NRC RAI 1-1:

Provide tolerances on the licensing drawings.

Holtec's Response to RAI 1-1:

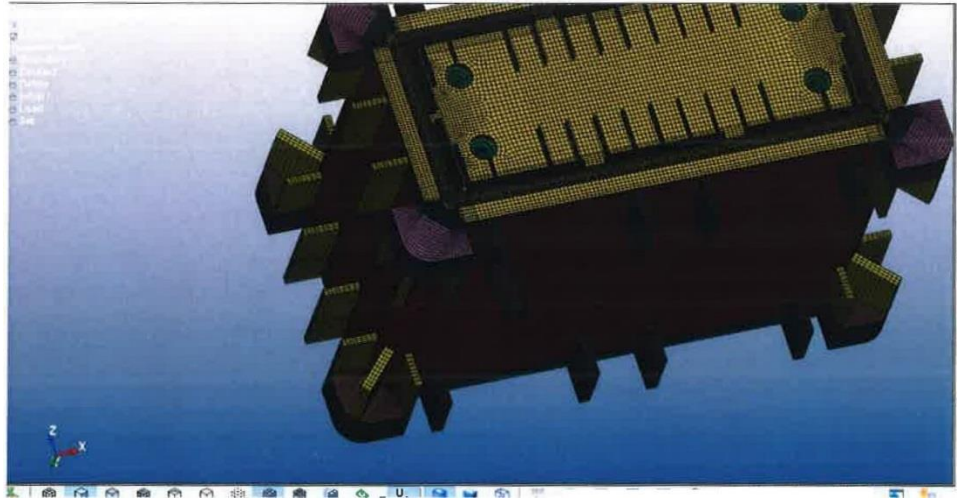
Justify the ratio of hourglass energy to internal energy observed for certain parts of the ATB-1T package during drop simulations in LS-DYNA.

As stated by the applicant, the ratio of hourglass energy to internal energy should be kept to a ratio of 10% or less, as hourglass energy indicates that a nonphysical part of internal energy is present in the model, which, in turn, implies that deformations and the overall physical behavior of the part may not be realistic simulated.

Several drop simulations, such as the 30 ft top end drop, exhibit ratios for certain parts which grossly exceed 10%; as an example, the top lid of the BTC (model part 29) observes a ratio of 130%, part 23 (intermediate dose blocker plate) in the model observes ratios of greater than 30%, and several others parts, not mentioned here, exceed 10% by smaller amounts.

It is correctly noted that if the hourglass (zero energy mode) contribution is significant (more than 10% of the peak internal energy), it may distort the dynamic response of the cask and its components.

In the revised analysis, it is ensured that:

1. The total hourglass energy is less than 10% of the peak internal energy of the cask.
2. The identical measure (ratio of total hourglass energy to the peak internal energy) for individual parts is also minimized to the extent practical without compromising the overall runtime.

The noted BTC components are also ensured to meet the above criterion.

Puncture Bar Centered over Sealing Surface at Side Impact Absorber
(Side Drop Orientation Shown)

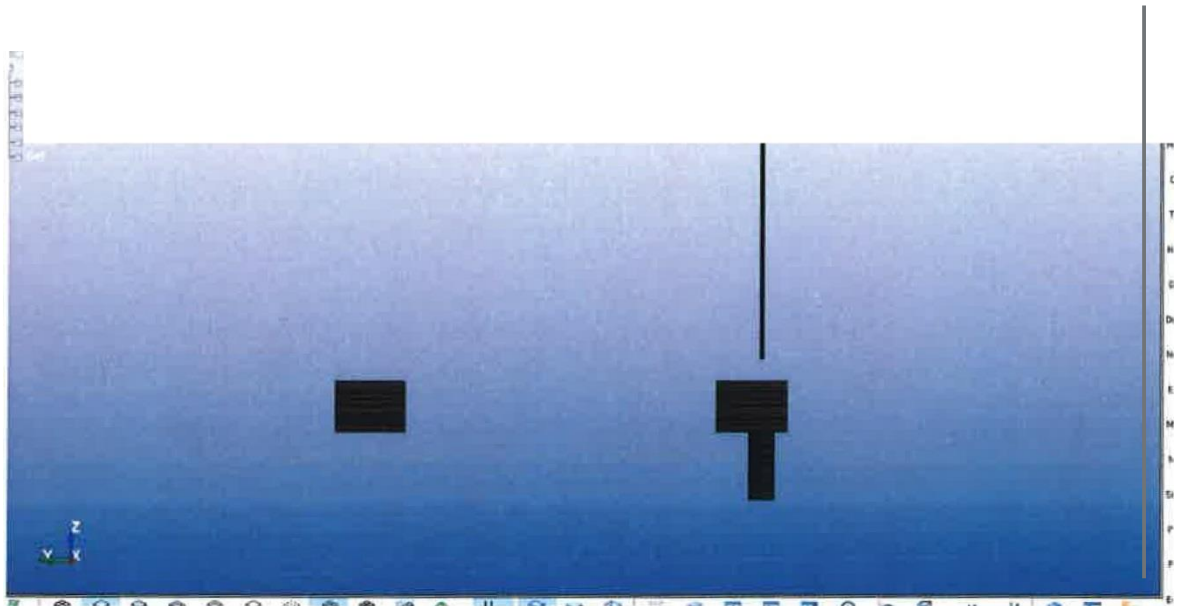
Describe the condition of the sealing surface of the package when subject to the 9 m side drop, followed by a 1 m puncture drop at the side impact absorber near the sealing surface. Clarify and justify how containment requirements will be met given inelastic deformations are observed for the 9 m side drop.

The package's sealing surface (cladding) experiences inelastic deformations after the 9 m side drop next to the side aluminum impact absorbers (BOM 42 of the licensing drawings). It appears that additional damage could be experienced in this region as a result of the 1 m puncture drop (cumulative damage) in the area as shown:

Additional damage in this region could further hinder and jeopardize the package's ability to maintain containment regulatory requirements.

A justification that containment requirements, such as leak rates, will be met given inelastic deformations at the closure region after the 9 m side drop has not been provided (see also containment RAI 4-1). The applicant shall update the application and all associated calculations, as necessary.

To address NRC staff's concerns, an additional puncture simulation is performed as discussed in Appendix C of HI-2177539 Revision 4.

This sensitivity simulation considers a 1-m puncture drop wherein the cask is dropped sideways onto the puncture bar aligned with the seals. Furthermore, this simulation accumulates the damage and deformations (strains) from the 30-ft side drop as the initial condition before subjecting the cask to 1-m side puncture. The analysis and the results from this simulation are documented in Appendix C. The result summary from this analysis is the following:

1. Since the cask center of gravity is offset significantly from the sealing location or point of impact, the cask is subject to rigid body rotation before imparting any significant damage to the HI-STAR ATB 1T package.
2. The seal initial strain result from 30 ft. drop and the corresponding result subsequent to the final 1-m puncture drop remain unchanged. This indicates that the 1-m puncture does not contribute to additional deformation in the seals.
3. All other key containment results subsequent to the 1-m puncture drop remain essentially the same as its initial condition, i.e., 30 ft side drop simulation. There is superficial damage to the outer shell which is not critical for the safety determination of the package.

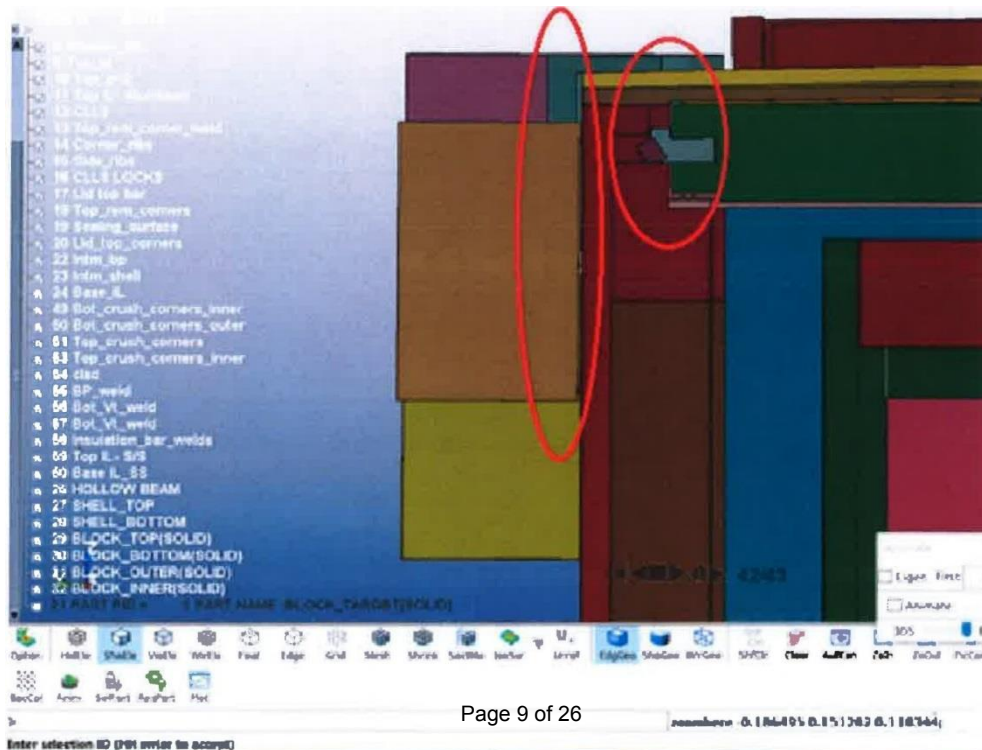
Clarify the location of the aluminum impact absorber plates on the licensing drawings and their attachment in drop simulations.

Licensing drawing 9786 (Sheet 7 of 7) depicts the relative arrangement between aluminum impact absorbers (BOM part 42). However, their location relative to the cask itself has not been provided. These plates are partially missing from the 1 ft bottom end drop, 1 ft top end drop, and 30 ft BOT CGOC + 1 m puncture drop simulations. In the case of the 1m drops, they also do not appear to be connected, as shown below. In addition, it appears that part 16 of the model, CLLS locks, rotates unnaturally through its neighboring parts.

Impact absorbers are intended to reduce the demands on the containment boundary. It is unclear how "loose" or "missing" impact absorbers will affect the package's performance. The applicant shall update existing drop simulations and the application as necessary, including the licensing drawings.

The revised dwg. 9786 shows the location/positioning of all the crushable attachments (impact absorbing components) relative to the cask.

It is correctly noted that some of the crushable attachments, which are not critical for a particular drop orientation, do not correspond to the actual sizing and positioning shown on the dwg. 9786. For example, the side attachment bars (i.e., part 42) are only shown for representation in the simulation model used for end drops. Likewise, the top and bottom bars are not critical when performing the side drops. This simplified representation is justified and is acknowledged in the calculation package HI-2177539 Revision 4. This modeling simplification has no adverse influence on the package safety determination.

It is also ensured in the revised calculation HI-2177539 Revision 4, that part 16 of the model viz. CLLS lock has proper contact with the adjacent cask components.

Figure 1: Plot of residuals at the end of the 30-minute fire (previous 200 iterations plotted for clarity):

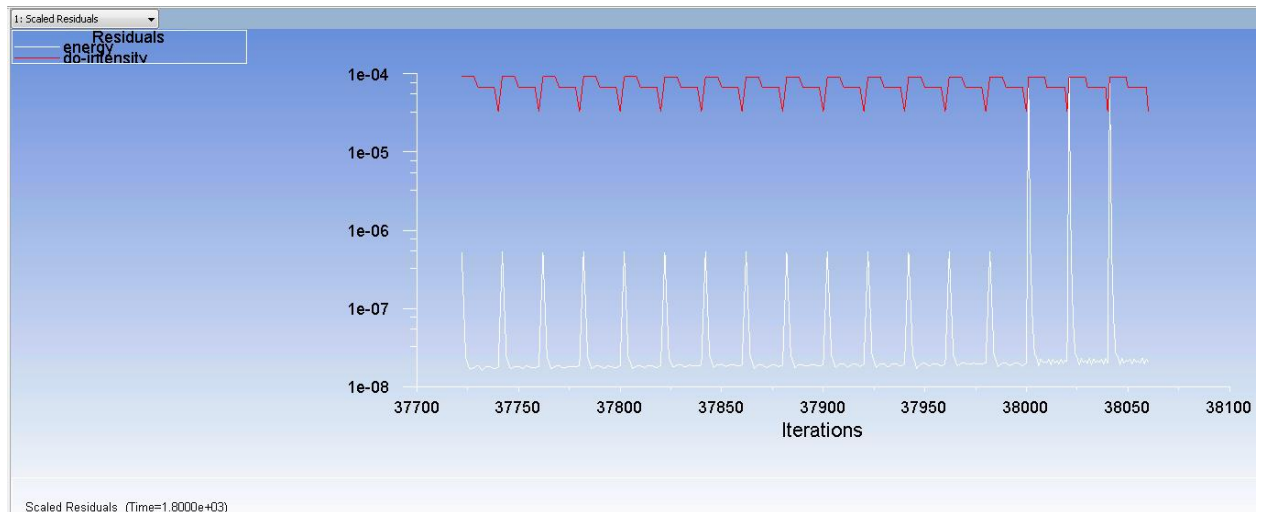
Clarify the surface temperature of the package after the 30-minute fire to ensure the boundary conditions for subsequent analyses are appropriate.

A review of the T200-half-uniform-1d75kw-fire-initial.cas file appeared to show an approximately 388°C external surface temperature 30 minutes after the start of the fire. This is different from expected temperatures, considering that the surface had been exposed to an 800°C fire for 30 minutes and Figure 3.4.1 from the previous application (Revision 1) reported temperatures over 750°C.

Recognizing the uncertainty in the temperature above and the presence of oscillatory-like swings at the end of the energy balance residual plot (T200-half-uniform-1d75kw-fire-initial.cas), the applicant shall demonstrate and clarify that the hypothetical accident condition thermal results have reached convergence (e.g., monitoring seal temperature throughout the timesteps) to ensure that reported values are representative.

Considering that the calculations have been updated, the response below is based on the calculations performed in support of the proposed revision 3 of the SAR and Rev. 3 of HI-2156585.

It is to be noted here that the containment boundary components, whose temperatures have been reported in Table 3.1.2 of the SAR, are not directly exposed to the fire boundary conditions. All the components exposed to the fire boundary conditions in the thermal model are listed in the table above. Neither in Figure 3.4.1 of the previous revisions nor anywhere in the proposed revision 3 of the SAR have the temperatures of the components listed in the above table been reported. The external surfaces of the cask that are directly exposed to the fire indeed show a maximum temperature of 662°C (1224°F), which is in line with the reviewer's comments.

The transient fire evaluation is performed until all the containment boundary components reach their respective peak temperatures and start to recede. That is, the calculations are not extended until the closure lid seal temperature reaches an asymptote. This is because the maximum temperatures is already computed soon after 30 minute fire ends. The transient calculations are performed with large number of iterations per every time step which results in atleast 3 to 4 orders of drop in energy residuals as shown in Figure 1. Additionally, the converged mesh is adopted for the transient simulation to compute the closure lid seal temperatures.
